Service Letter No. 365

SUBJECT: Special Bolt for Nose Gear Drag Link

MODELS AFFECTED: PA-24 and PA-24 "250" Comanches
Serial Numbers 24-1 to 24-1964 inclusive

SPECIAL BOLT
22066-00

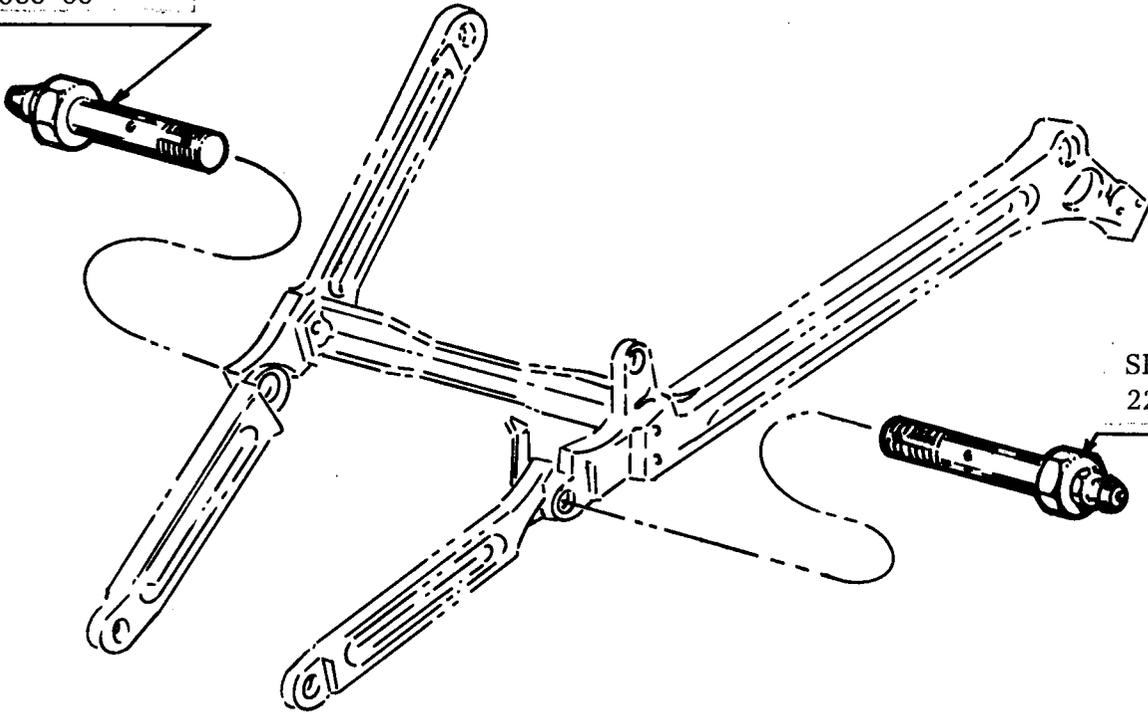
Service reports indicate that over extended periods of operation, the nose gear drag link bolts and bushings installed in the aircraft indicated above may show signs of wear and galling.

A special bolt is now available for use in the subject aircraft. This bolt incorporates a lubrication fitting which will permit lubrication at the 100 hour inspection. It is recommended that this special bolt be installed in the referenced aircraft as it will reduce the need for replacement. See Sketch on the reverse side of this Service Letter.

Removal and inspection of this bolt will be adequate at each 1000 hours of operation, provided that it has been properly lubricated at 100 hour intervals.

Aircraft equipped with the standard AN bolts should have the bolt removed for inspection of bolt and bushing, and be repacked with grease every 100 hours.
